FORM APPROVED
OMB No. 1004-0137
Expires: March 31, 2007**SUNDRY NOTICES AND REPORTS ON WELLS**

Mobil Federal #10

30-015 - 37369

**Mobil Federal 10
OXY USA Inc.
November 14, 2011
Conditions of Approval**

OXY USA Inc.
Mobil Federal #10
API No. 30-015-37369

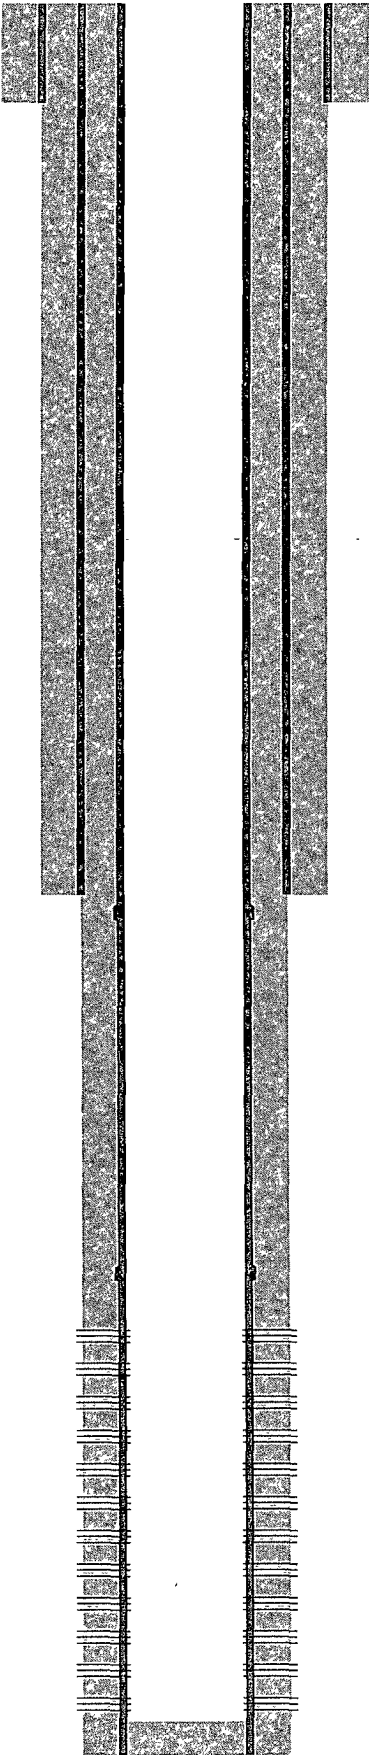
- 6. Operator limited to 3700 psi on the frac down the casing. This is based on 70% of the 5.5" 17# J-55 casing's burst rating.**
- 7. Operator to submit a subsequent sundry with details of work performed including a new well test. Due to classification as one pool under order R-10086, no completion report is required.**
